BAe AIRCRAFT
BULLETIN FOR DE HAVILLAND MOTH AIRCRAFT

DOCUMENT TYPE AND REF No TECHNICAL NEWS SHEET CT (MOTH) No 29 Issue 3

TITLE: FUSELAGE: LATERAL TIE RODS - FRACTURE AT WING JOINT FITTINGS.	CLASSIFICATION MANDATORY
1. PLANNING INFORMATION A. Effectivity All Variants of DH 60, 82, 82A, Queen Bee and 83 Moth Aircraft B. Reason During routine maintenance on a DH 82 aircraft it was found that the lateral Fuselage Tie Rod at the aft position had sheared at its location with the spar attachment fitting. Subsequent investigation found the failure was a result of fatigue cracking in the thread root. In addition the forward Tie Rod (which had not fractured) was distorted and found to have been manufactured from material of incorrect specification with a lower tensile strength. C. Description This Technical New Sheet (TNS) CT (MOTH) No 29 Issue 3 calls for both lateral Fuselage Tie Rods to become "lifed items" restricted to a service life of 2000 flying hours or 18 years (whichever is sooner) and introduces a procedure for the examination of the aircraft structure following a heavy landing, following undercarriage trauma and at annual inspection. Undercarriage trauma is defined as hittin

FIGURE 1

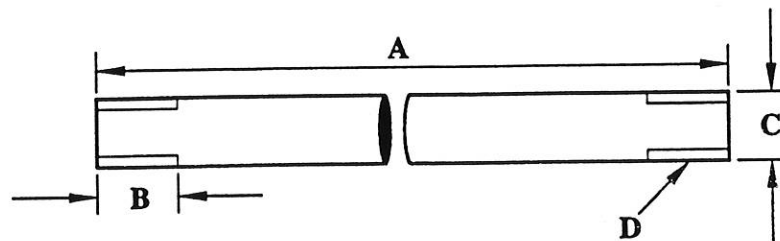
NOTE: All Rods to be manufactured as shown in Figure 1. Operators with queries regarding applicability of parts should contact BAe in accordance with Paragraph 4 (REPORTING).

- (1) Remove or stow the wings in accordance with the Maintenance and Repair Manual.
- (2) Refer to Figure 1 attached and locate the Spar Joint Fittings applicable to type at fuselage joint indicated, on both the Port and Starboard sides of the aircraft.
- (3) Remove the securing nuts and withdraw the two lateral Fuselage Tie Rods.
- (4) Using cleaning fluid and a lint free cloth remove all grease and dirt from the surface of the Spar Joint Fittings particularly around the periphery of the Tie Rod location holes.
- (5) Examine the Tie Rod location holes using a strong light source and 10 X magnifier for signs of ovality. Where these holes are found to be elongated the fitting should be declared scrap and replaced with an appropriate new item.

JOINT FITTING (Pt No H34640/1)
Examine holes for signs of elongation

- (1) Install new tie rods and run up the securing nuts by hand "finger tight". Tighten and torque load the nuts to 2 - 2.5 lbf ft (2.71 - 3.39 Nm) on wood constructed aircraft and 7.5 - 8.5 lbf ft (10.17 - 11.52 Nm) on metal constructed aircraft. A little further tightening may be necessary so that the next slot aligns with the split pin hole. Secure with a split pin and apply protective treatment.
- (2) Refit wings and re-rig the aircraft in accordance with the Maintenance and Repair Manual.
